ORIGINATION FORM

Proposed Revisions to a Standard Plans Index
(Please provide all information — Incomplete forms will be returned)

Index Number: 700-011
Sheet Number (s): 2 of 2
Index Title: Single Column Cantilever Ground Mounted Sign

SINGLE COLUMN CANTILEVER
GROUND MOUNTED SIGN

BASE AND FOUNDATION DETAIL

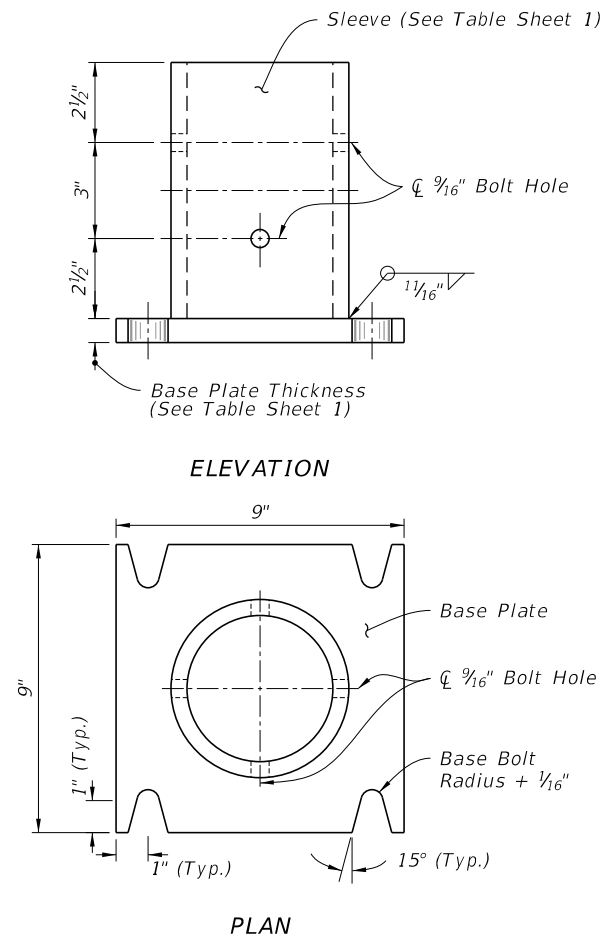
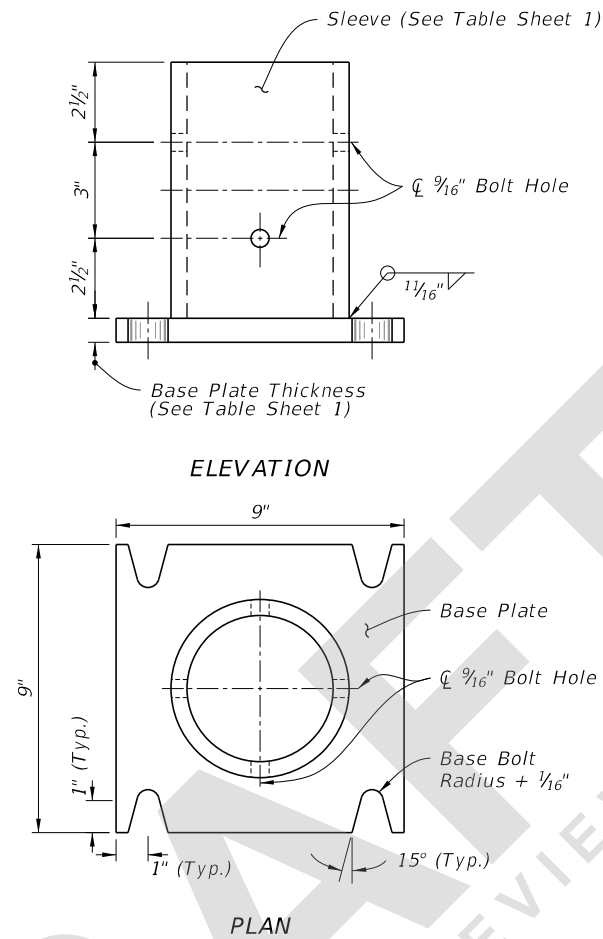
Sheet 2: Changed "Class I" to "Class II" in the BASE AND FOUNDATION DETAIL.

Class I Concrete
Stub
CHANGED TO: Class II

Changed to reflect Materials specification change that removes the designation for Class I Concrete.
Please see the attached Standard Specification Section 346 DRAFT for the Class I revisions proposed by the State Materials Office.
